METROPOLITAN EDISON COMPANY

December 1, 1978
GQL 1919

Three Mile Island Nuclear Station, Unit 1 (TMI-1)
Operating License No. DPR-50
Doc'et No. 50-289
Fire Protection Program-Fire Doors

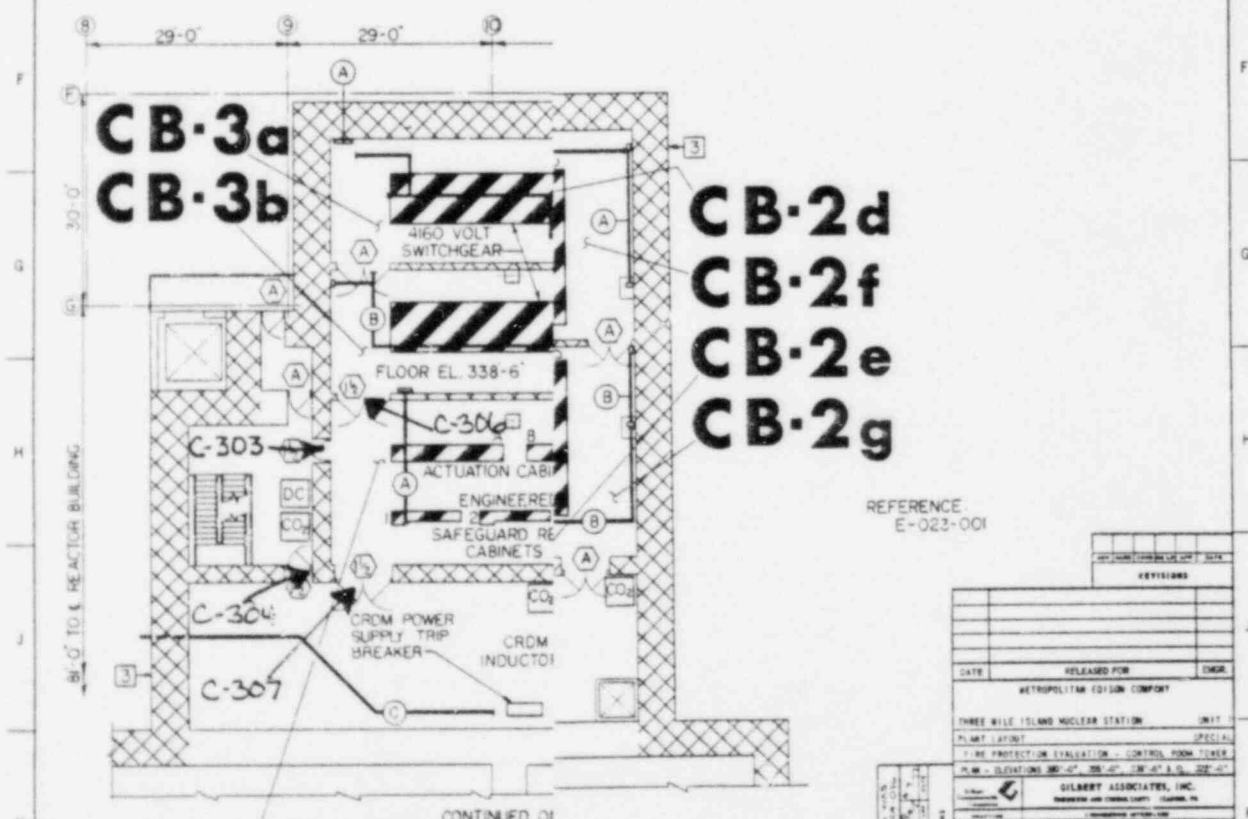
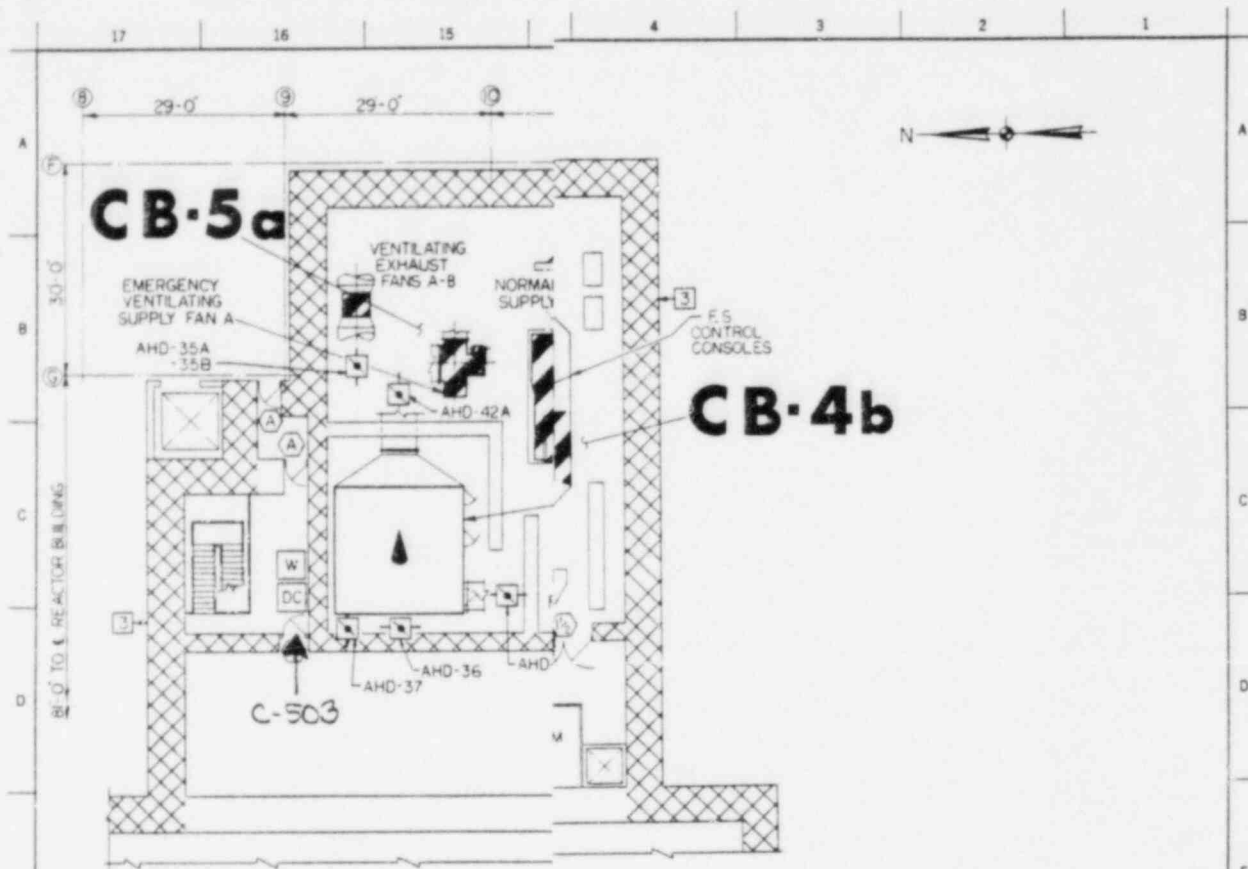
Doors and frames C-403 and C-423 are being replaced with bullet-resisting doors as part of the security program. These doors will be of A label construction.

Doors and frames C-131, C-415, C-418 and S-157 will be replaced with assemblies bearing the UL A label.

The frames for doors C-207, C-304, C-307, C-312 and I-101 will be replaced, but the doors and hardware will be reused. The doors are fabricated in accordance with A label requirements. However, the doors are oversized and therefore were not subjected to the standard fire tests required for label attachment.

Met-Ed proposes to leave the following doors in place as is: C-205, C-206, C-303, C-404, C-503, C-202, C-204, D-108, C-306 and C-124.

Doors C-205, C-206, C-303, C-404 and C-503 are listed on the Gilberts Associates, Inc. (GAI) drawings, the manufacturer's shop drawings, and purchase order documentation as UL B label doors and frames. The B label is considered adequate for these locations consistent with Fire Protection Handbook (14th Edition, Section 6, Chapter 8), published by the National Fire Protection Association.

The doors and frames for C-202, C-204, and D-108 are described on the relevant documentation as UL A label construction. Doors C-202 and C-204 are oversized doors and could not be tested as mentioned above.

Door C-306 is an oversized double door assembly in a three-hour rated metal fire wall. The frame is tack welded to the jamb and head channels and anchored through the door stop into the jamb channels by bolting. In addition, the jamb and head channels are covered by fireproofing materials. It is Met-Ed's opinion that removing the frame, and the resulting damage to the rated metal fire wall, would result in a fire barrier less effective than what presently exists.

Door C-124 is a rolling steel door constructed in accordance with UL A label requirements. It does not carry a label because of its size and because of a wicket installed in the door.
